APPENDICES

- Appendix I** The Accepted Drainage Proposal of the Previous Application No. A/HSK/424
- Appendix II** Revised Drainage Proposal
- Appendix III** The Accepted Fire Service Installations Proposal of the Previous Application No. A/HSK/424
- Appendix IV** Revised Fire Service Installations Proposal

Compliance with Approval Condition (a)
Planning Application No. A/HSK/424

**Proposed Temporary Warehouse (Excluding Dangerous Goods Godown) with Ancillary Facilities
for a Period of 3 Years in "Village Type Development" and "Open Space" Zones,
Various Lots in D.D. 124 and Adjoining Government Land, Ha Tsuen, Yuen Long, New Territories**

File:	DWG NO.
Scale:	HS/424/D02
Date:	25/4/2024

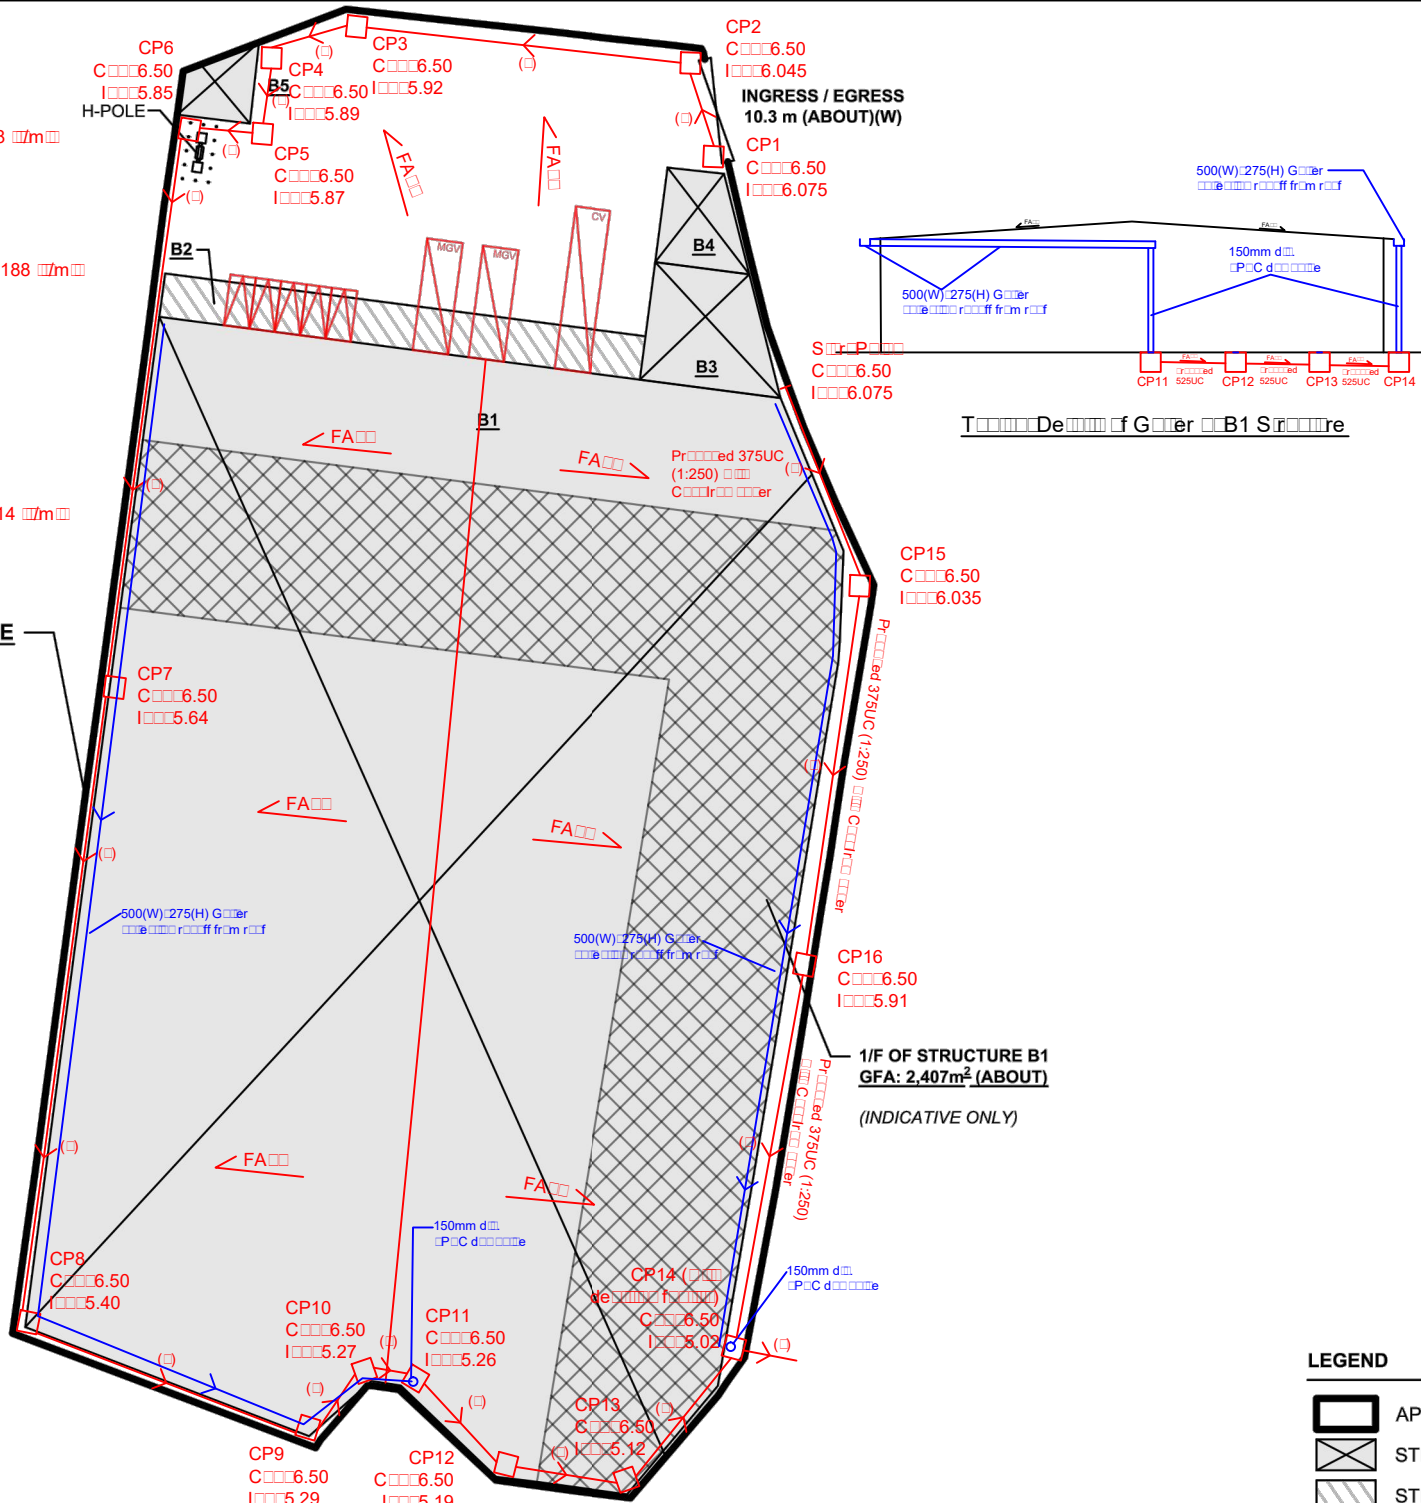
Comments of the CE/MN, DSD (Contact Person: Ms. Vicky SY; Tel: 2300 1347)		
(i)	<p>The U channel at the eastern side of the application site proposed on the submission dated 28.2.2024 is deleted in this submission. Please clarify on the reason for this change. Please note that peripheral surface channels shall be provided along the site boundary to collect the surface runoff accrued on the application site and to intercept the overland flow from the adjacent lands.</p>	<p>Peripheral channel is provided (i.e. UC is provided at the eastern side of the application site) as shown at the revised drainage proposal (Appendix II).</p>
